Subject: Response to City Review Comments  
Proposed Hotel Expansion  
The Ritz-Carlton Laguna Niguel  
1 Ritz Carlton Drive  
Dana Point, California

In accordance with your request, Ninyo & Moore has reviewed the comments prepared by Zeiser Kling Consultants, Inc., on behalf of the City of Dana Point regarding our referenced geotechnical evaluation report dated August 9, 2007, for the Ritz-Carlton Hotel Expansion project. Our responses to the City comments requesting response/further evaluation are presented below. A copy of the City of Dana Point Geotechnical Report Review checklist is included in Attachment A for reference.

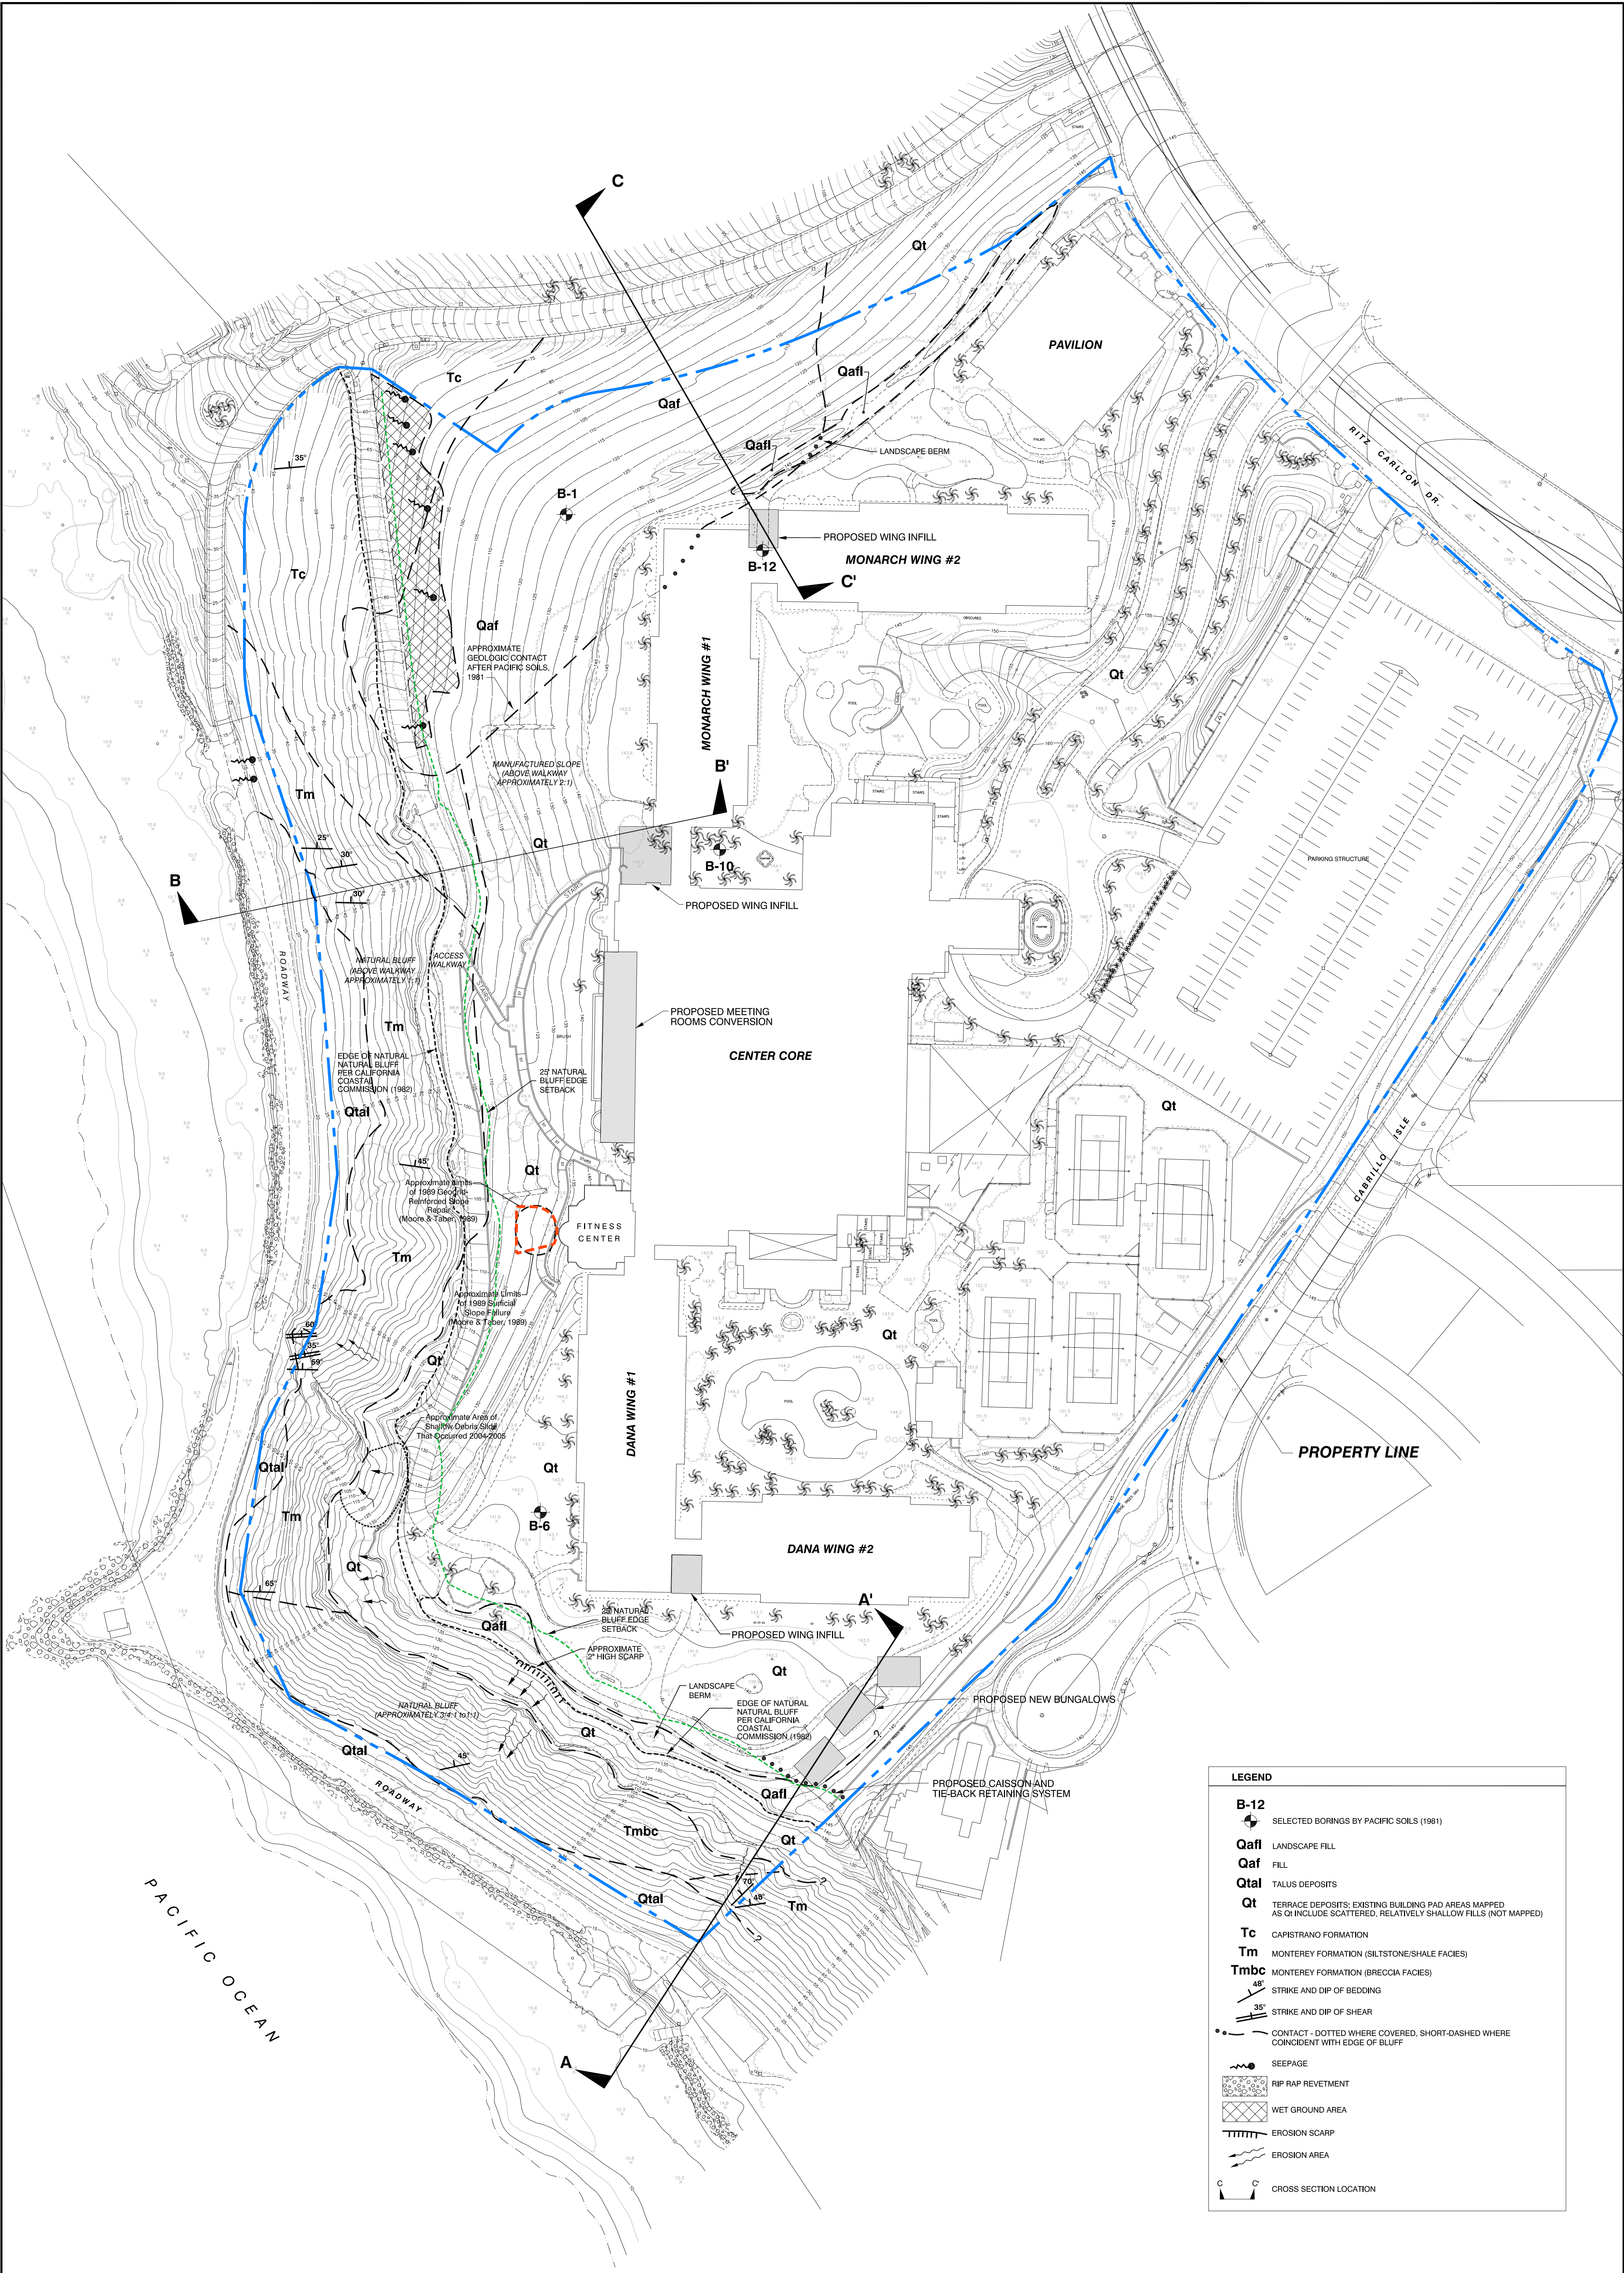
3. The bluff setback line does not appear to correspond to a 25 foot setback from the top of bluff line particularly in the "center core" area as shown on figure 6. Please review the setback line in relation to the top of bluff line and correct accordingly.

Thus, our mapping of the bluff edge on the west side of the hotel is consistent with the CCC's continuing delineation of the natural bluff edge seaward of the bluff path, marked "Access Walkway," as shown on Figure 1. The bluff edge along the south side of the hotel site is mapped at the top of the natural bluff on the seaward edge of the landscape berm as shown on Figure 1. This man-made berm was created as a landscape feature within the manufactured bluff top area. A line delineating the edge of the bluff at the project site is included in the geologic map and cross sections shown on Figures 1 through 4.

We have reviewed the bluff setback line and have made adjustments to reflect a more accurate depiction of the setback in relation to the top of bluff as revised per our response to Comment No. 2. The corrected setback line is shown on Figure 1.

As requested in Comment No. 9 below, the approximate locations of the 1989 surficial slope failure and subsequent repair areas are shown on Figure 1. The shallow slump occurred on the modified westerly facing bluff below the spa area and was described as approximately 35 feet wide and 27 feet long and 4 to 5 feet deep (Moore & Taber, 1989a). The slump was reportedly repaired by excavating a base keyway into the bluff, removing the slide debris, and replacing with a geogrid-reinforced compacted fill (Moore & Taber, 1989b). The bluff was restored, and re-occurrence of slumping in this area has not been reported by the Ritz-Carlton. During our site reconnaissance, we made observations of the area of the manufactured slope where the 1989 slump and slope repair reportedly occurred. The slope in this area is vegetated with landscape plants, and surface drainage devices are provided in this area. We did not observe indications of recent slope instability or increased erosion in this area. In our opinion, the reported shallow slump and repair area has not had significant impact on the stability of this bluff area and should not contribute to additional retreat of the bluff.

years ago (approximately in 2004 to 2005) are indicated on the Geologic Map, Figure 1. These areas are not in close proximity to the proposed wing infills or bungalows, and, as such, have not been depicted in cross section view.

<b><i>Ninyo &amp; Moore</i></b>		<b>CROSS SECTION A-A'</b>	FIGURE  <b>2</b>
PROJECT NO.	DATE	PROPOSED RITZ-CARLTON HOTEL EXPANSION 1 RITZ CARLTON DRIVE DANA POINT, CALIFORNIA	
207118001	3/08

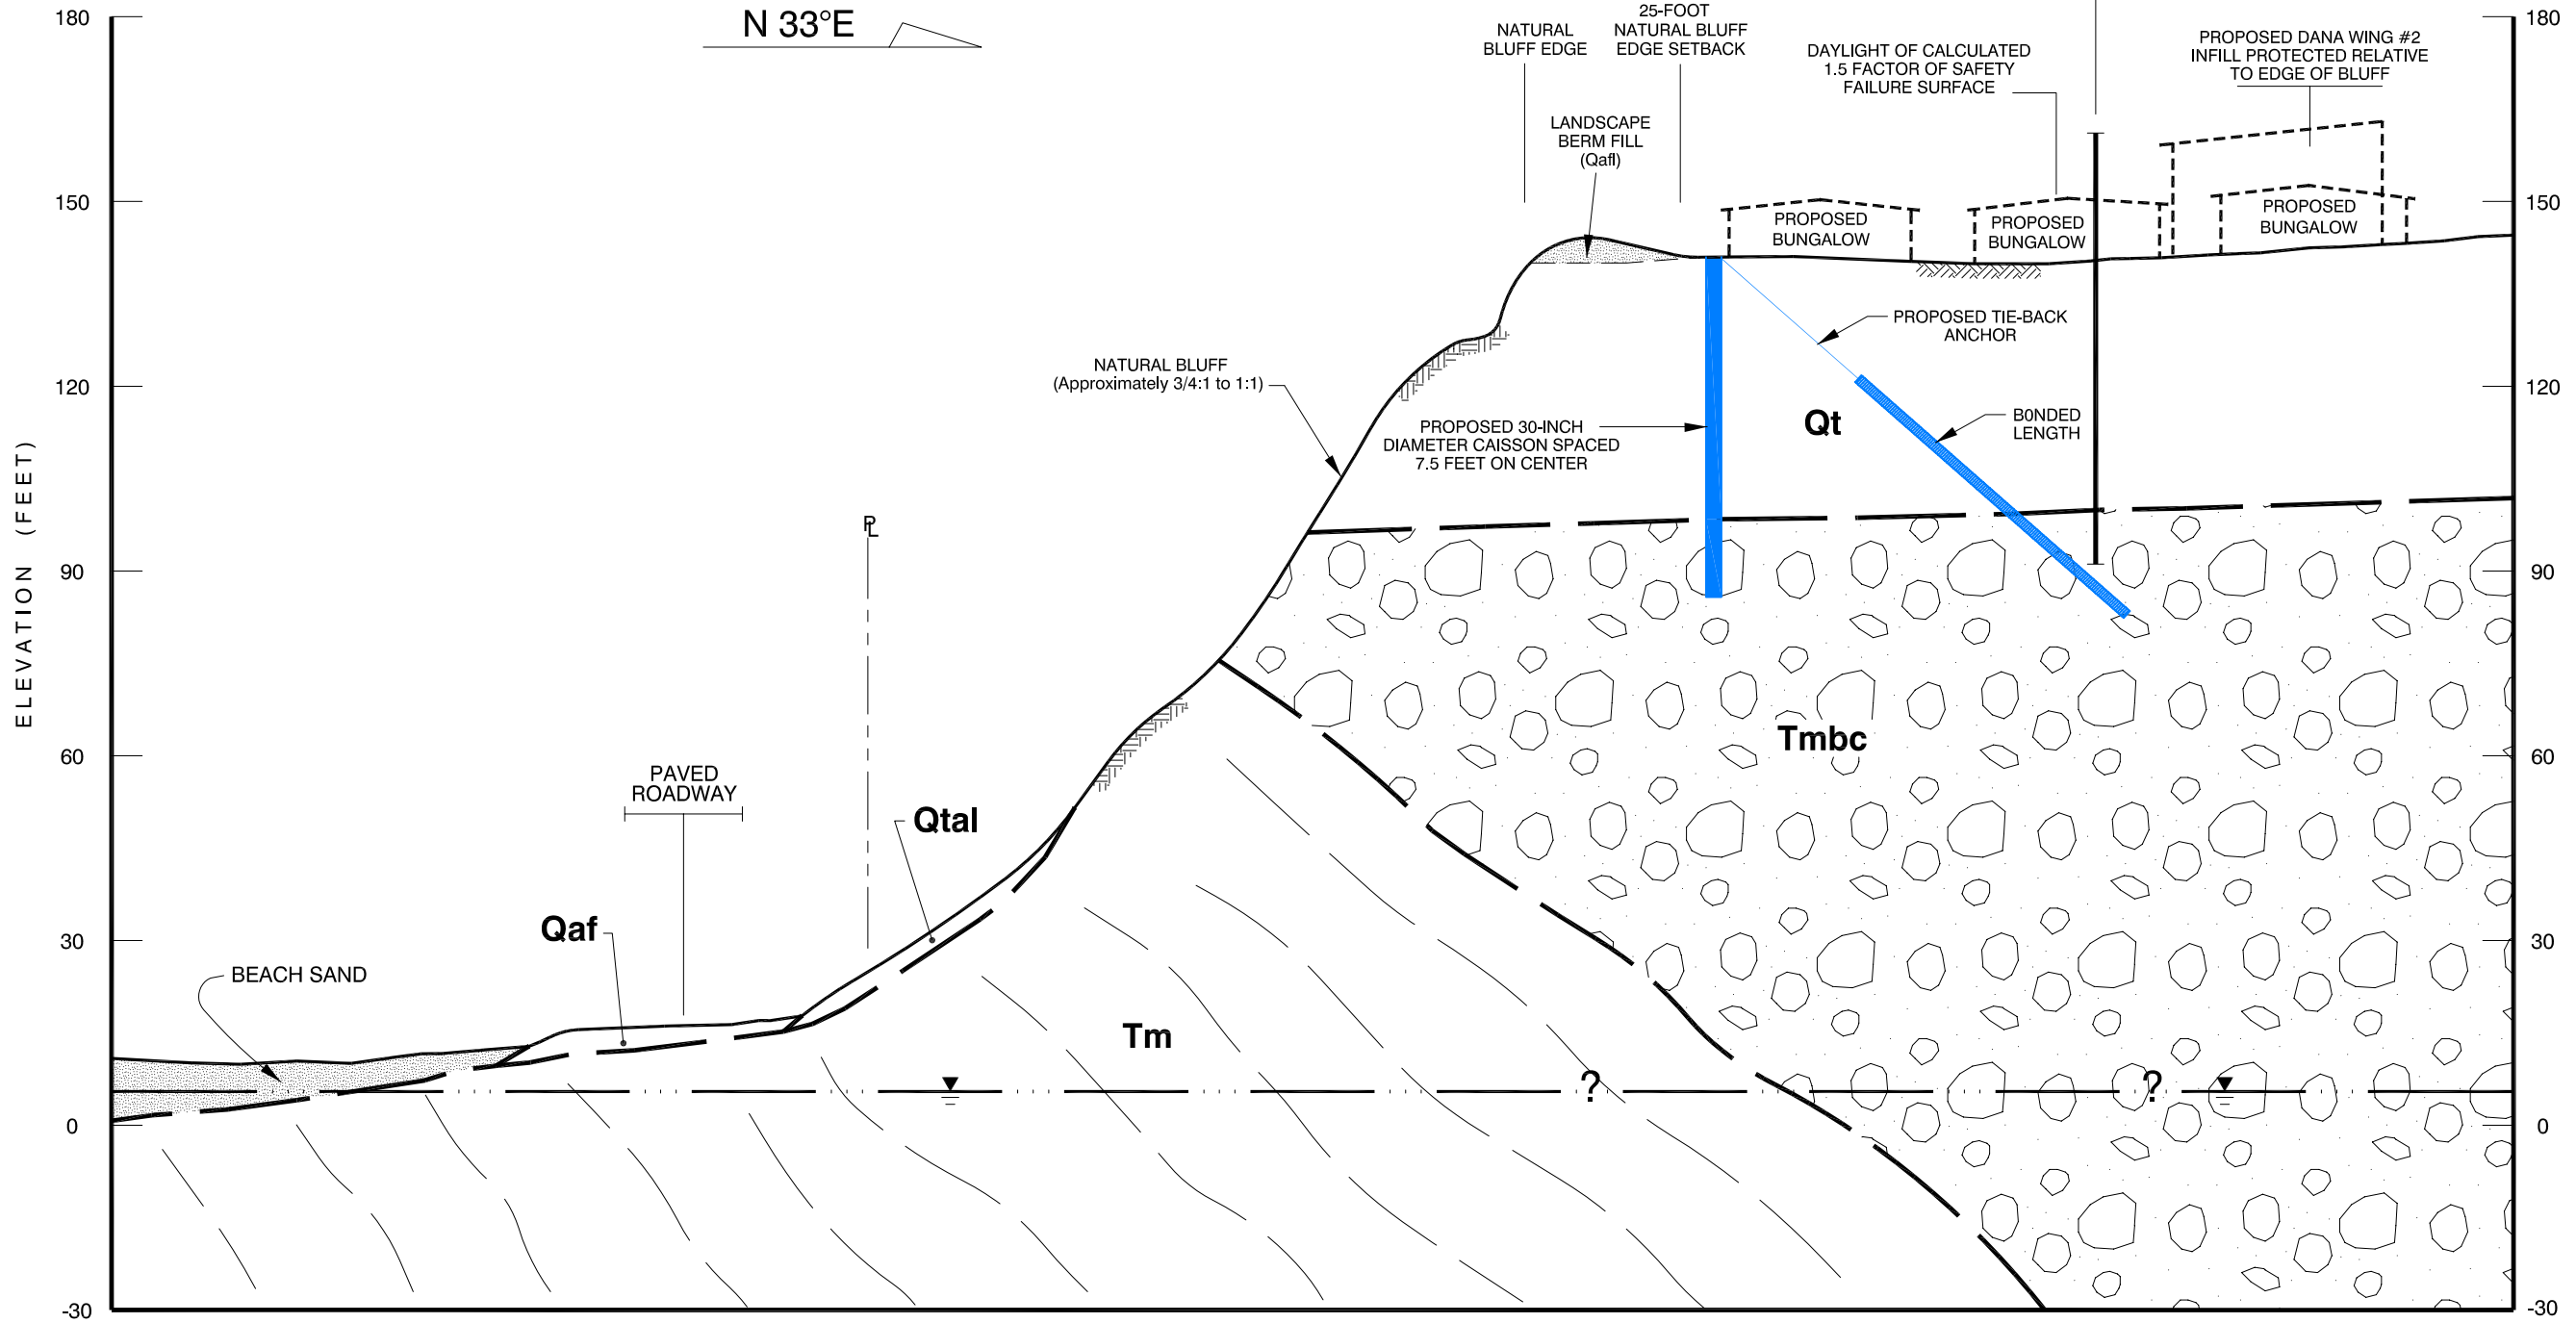
7. Please provide geologic cross-sections and slope stability analyses through portions of the proposed additions. Prior geotechnical data may be utilized at this stage to evaluate slope stability and geologic conditions. This information will be used to evaluate a variance to the coastal bluff setback. Logs of all relevant exploration points should be included.

Geologic Cross Sections A-A', B-B', and C-C' were prepared in order to perform preliminary slope stability analysis in the vicinity of the proposed bungalows and infill construction on the south, west, and north sides of the hotel (Figures 2, 3, and 4). Slope stability analysis was performed using the GSTABL7 computer program and the Modified Bishop Method. Our analysis included evaluation of the global stability (top to bottom of bluff) and separate evaluations of the stability of the upper terrace deposits for Sections A and B. An evaluation of both static and pseudostatic stability was performed. The shear strength parameters used in the slope stability
